West Carrollton City Schools
NEW ELEMENTARY SCHOOL
628 E CENTRAL LN.
DAYTON, OHIO 45449

DIM.
LETTERS

Client: WEST CARROLLTON CITY SCHOOLS 2-4

Project: INTERIOR SIGNS

Sign 1

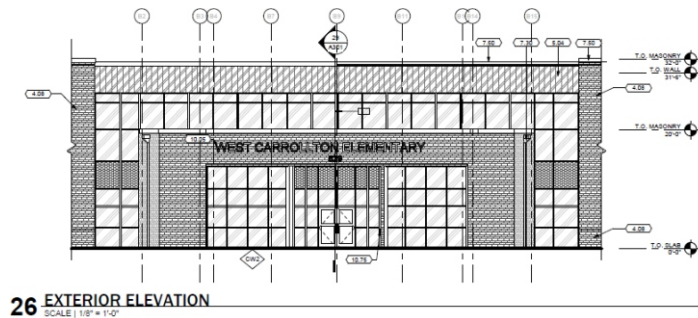
Century Gothic Font confirmed,
assuming this matches the Phase 1
projects. Paint finish color to be
MP25849 DURANGO GREY

Sign 2

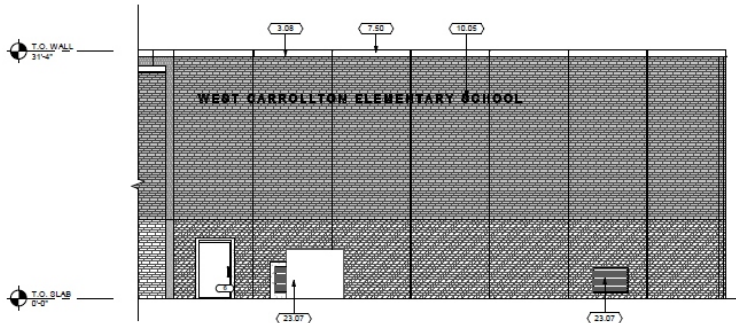
Century Gothic Font confirmed,
assuming this matches the Phase 1
projects. Paint finish color to be
~~MP25833 BONE WHITE~~

2024-10-15 MWH:
Revise to "Durango
Grey" MP25849.
